# **A G E N D A**

## **Architectural Review Board**

**December 21, 2022 – 5:30 p.m.**

Montgomery, Alabama  
Google  
Street View - Aug 2013

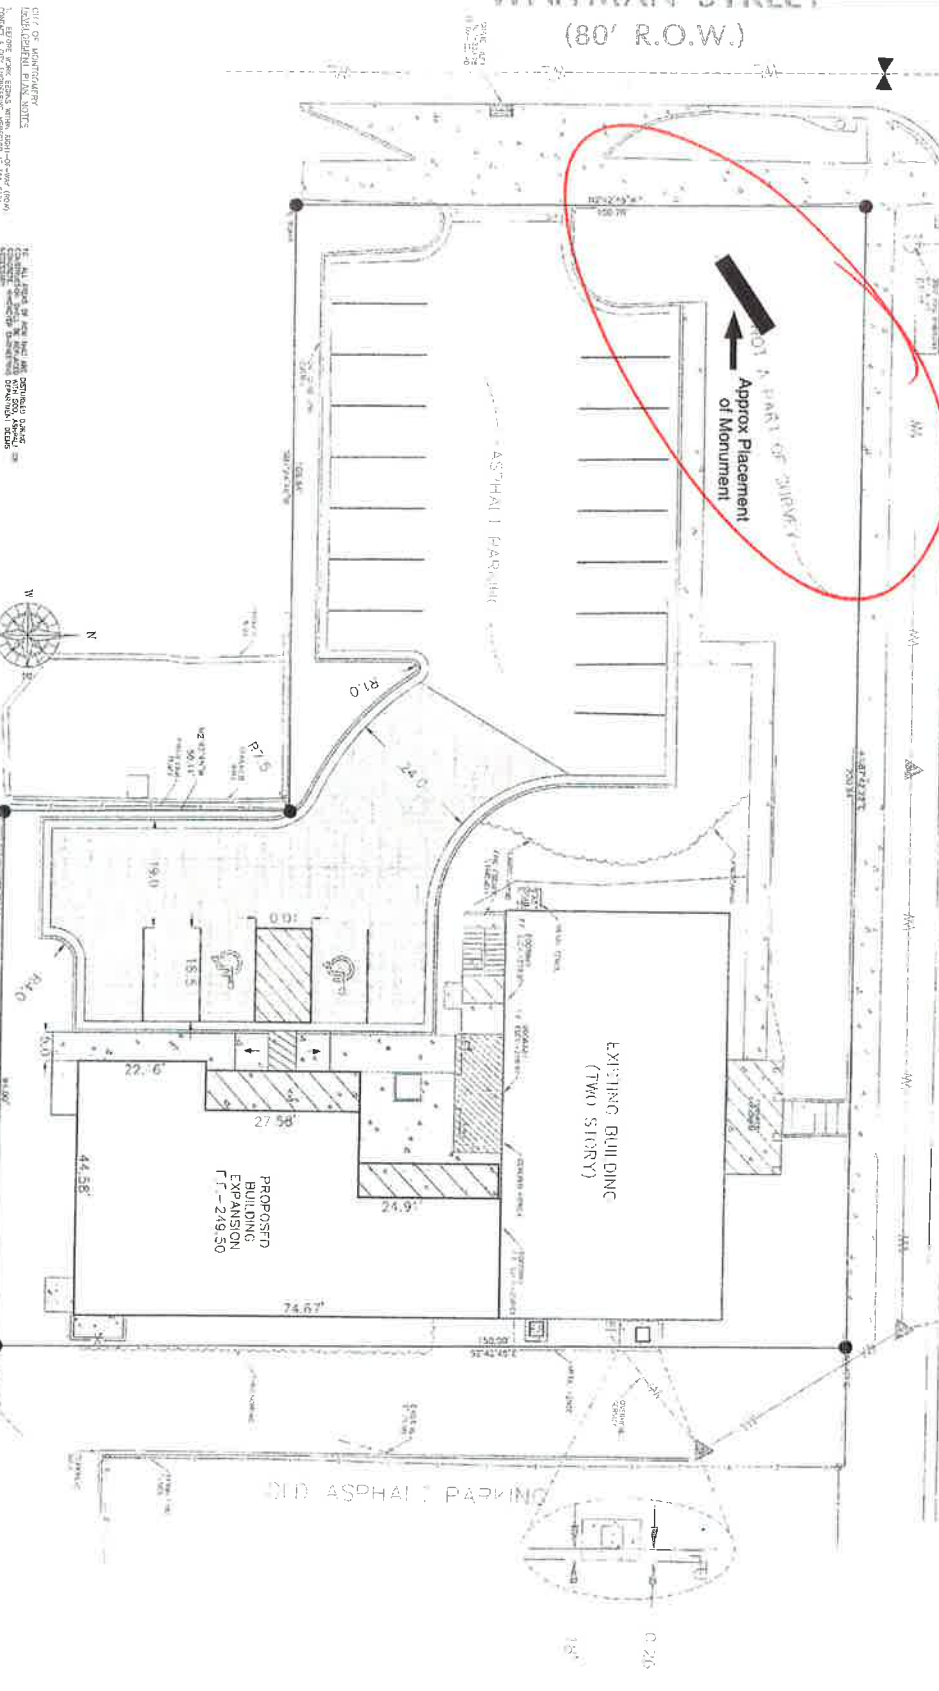
- One street view image shows the previous ID sign; a second shows a sign on a 4'x8' board in approximately the same location and orientation as the proposed sign. The monument is similarly sized, but will be set on the ground.
- The actual sign face is about 20SF, meets lighting guidelines, and with landscaping will only further screen the view of the parking lot. No objection.

**SITE PLAN**

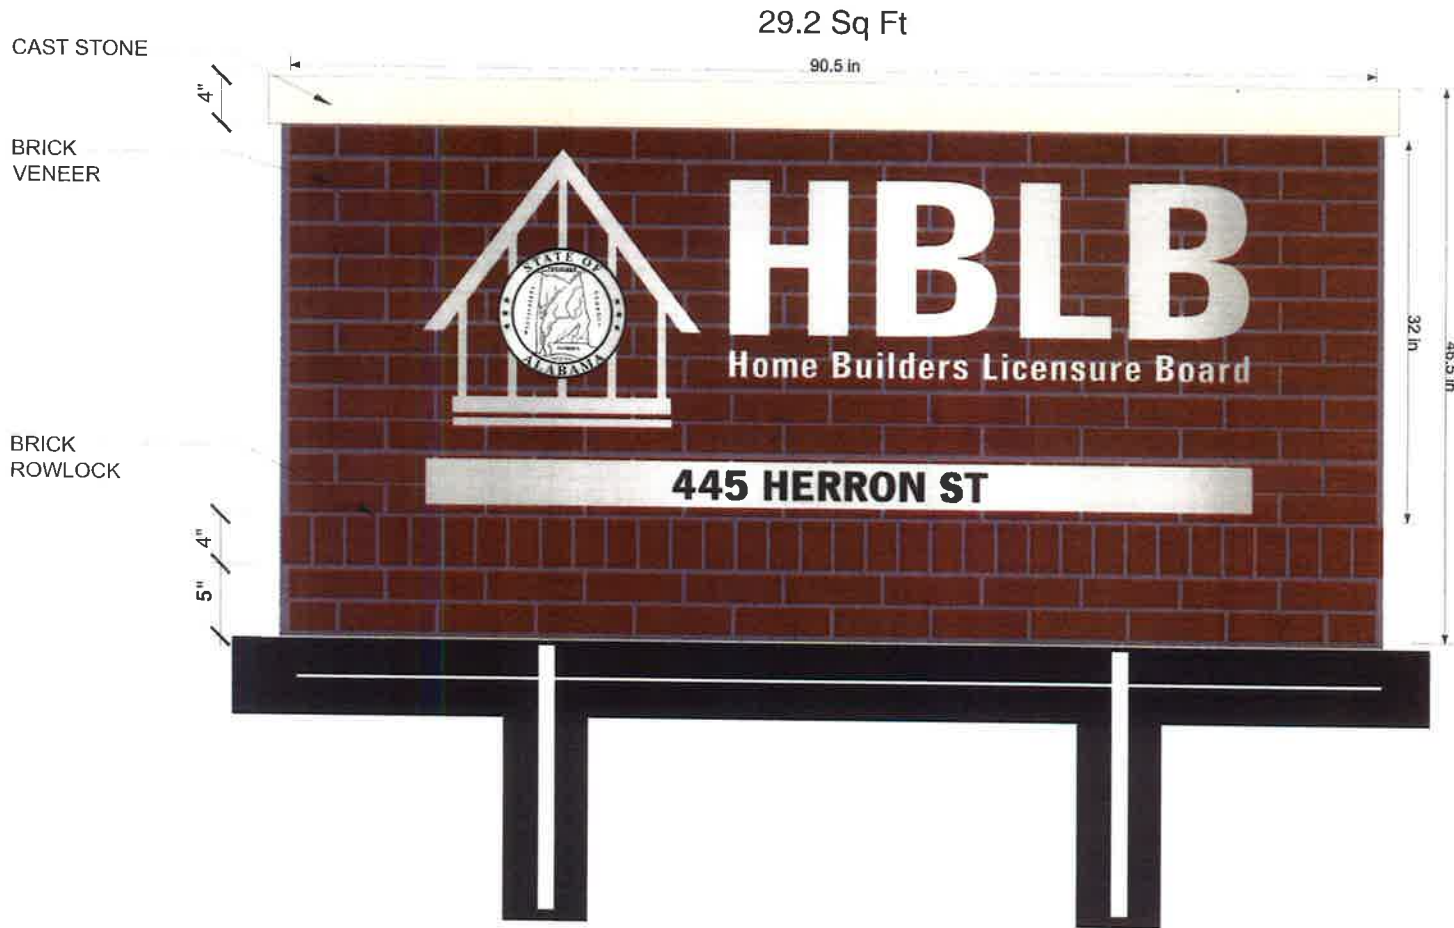
**REMARKS:** The petitioner is requesting permission to install a monument sign, approximately 4' tall and 7.5' wide at the corner of the property at Herron and Whitman Streets. The monument itself is 29.2 SF, while the sign face is approximately 20 SF (meets guidelines). The lettering will be flush mounted, with external LED solar lights proposed.

1200 S Lawrence  
Front porch floor area

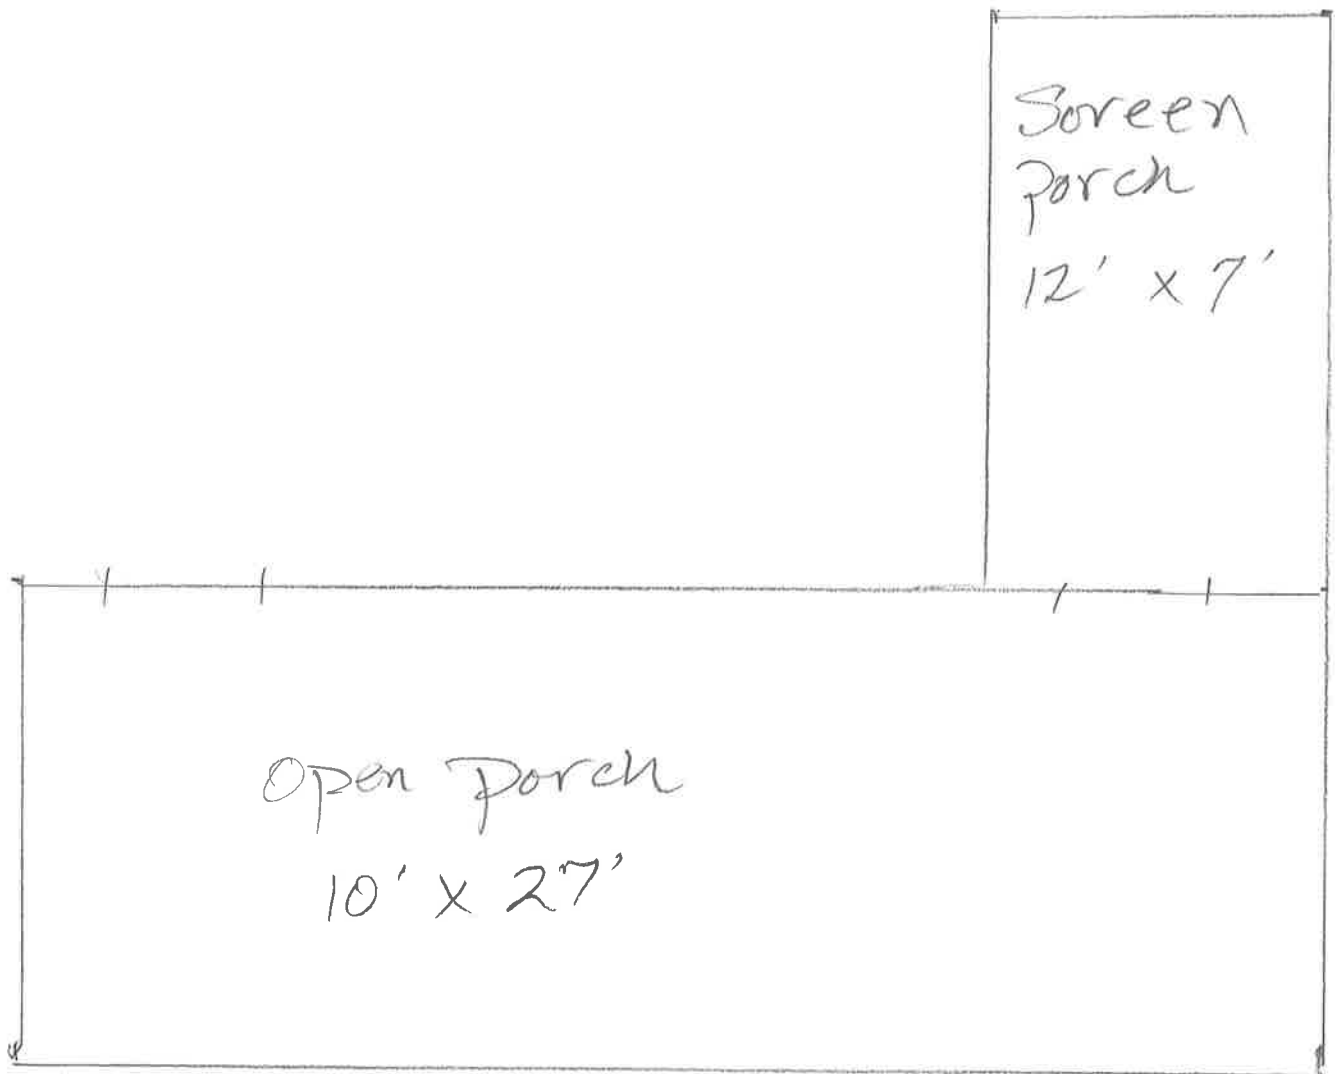
**REMARKS:** The petitioner is requesting permission to replace the deteriorated tongue and groove hardwood porch flooring with tongue and groove cementitious hardboard. The flooring will be Deckorators, kettle color. A sample will be provided by the petitioner at the meeting.

6A

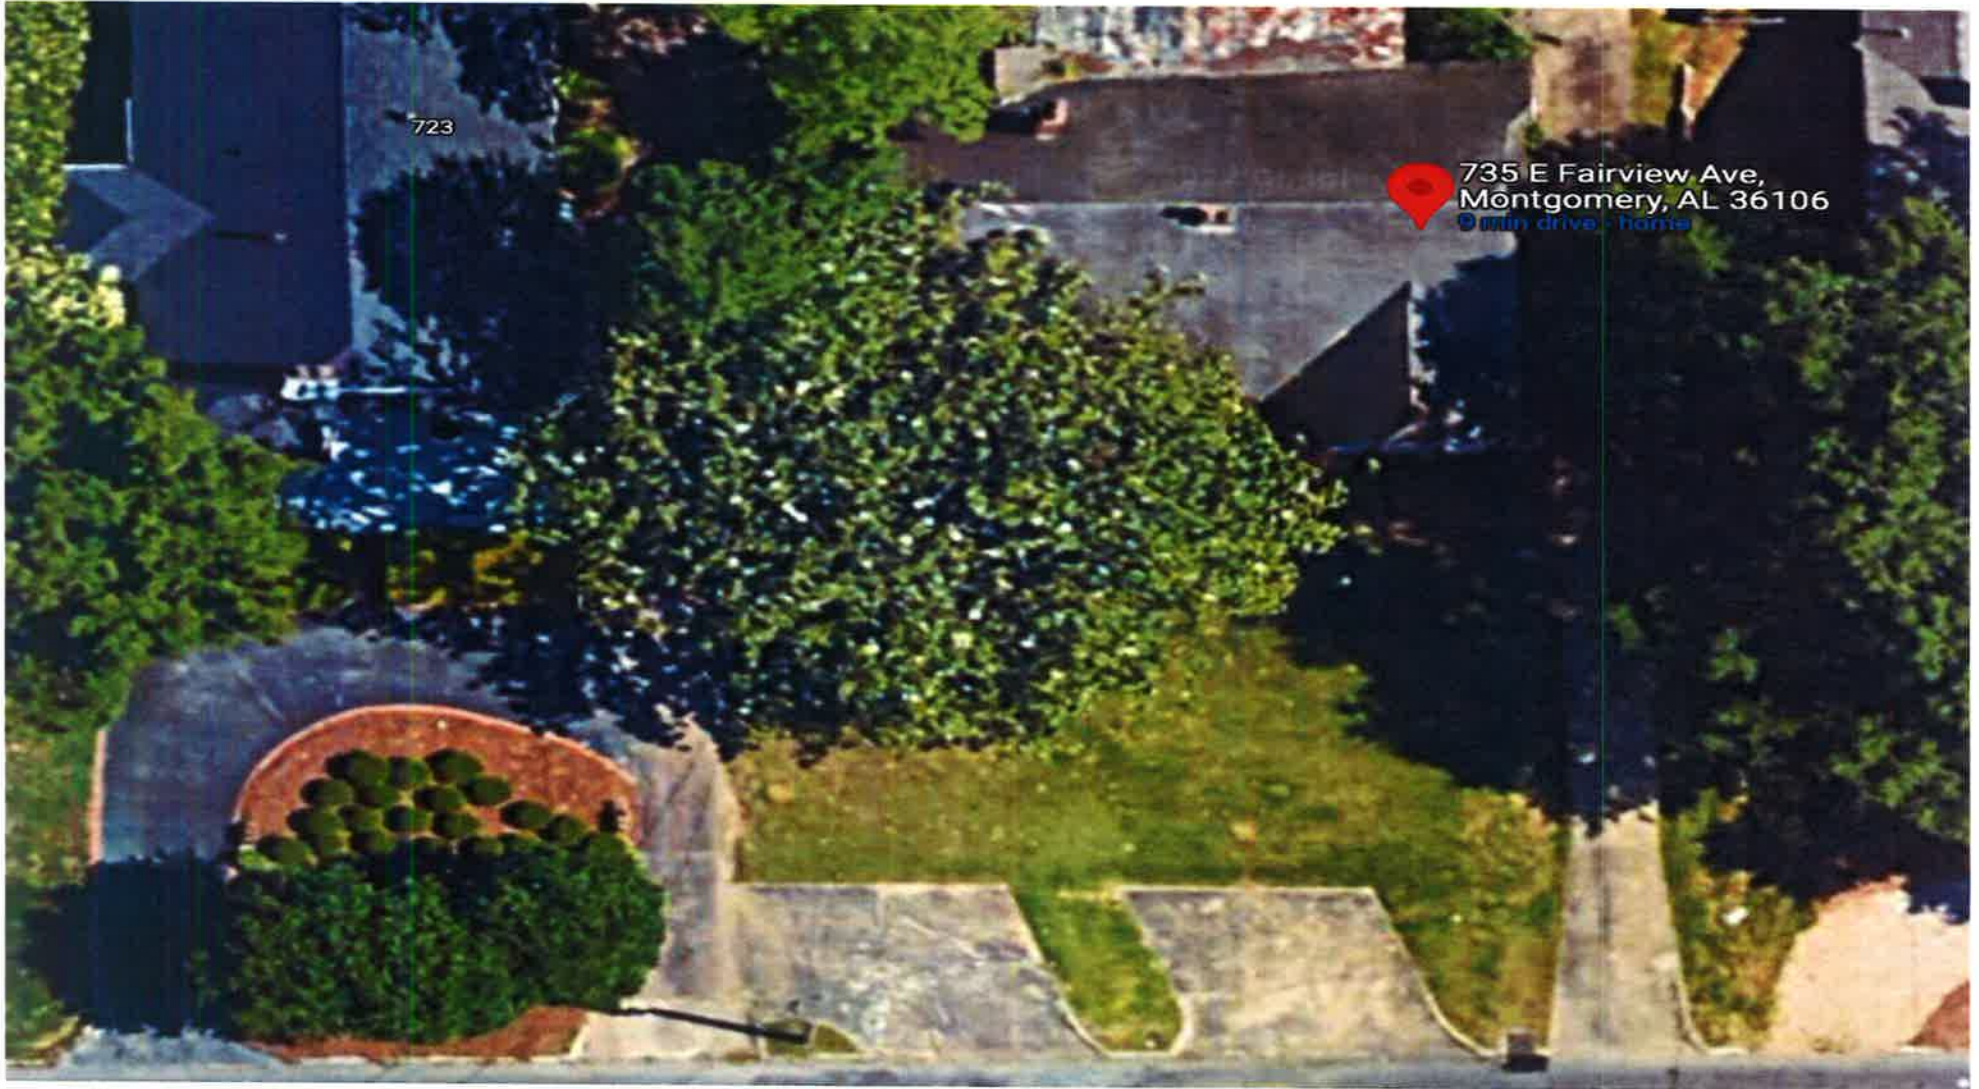
- The question for the Board with violations is always “Would we have approved this project as presented if the petitioner had asked first?” Just because it is there doesn't mean it has to stay there as is.

- The situation is always evaluated on a case by case basis as well as considering whether a differently executed plan would yield a similar result. This property has a driveway that goes behind the house to a garage, which offers some off street parking.

- The parking area has been pulled over to be out of the line of sight of the front door.
- Gravel should be clearly contained so it cannot spill into the street.

- When parking areas have been approved, they had to be able to provide enough screening from the street to soften the view of the parking area from the street. Parking area, if approved, should have a screen planted along the Fairview edge of the property and not present a continuous sea of gravel on the east half of the front lawn to the front property line. That will still afford the opportunity to not have to back out onto Fairview. Installed landscaping does not appear to meet the landscaping guidelines of evergreen shrubs, 18” high at installation, spaced 36” on center.
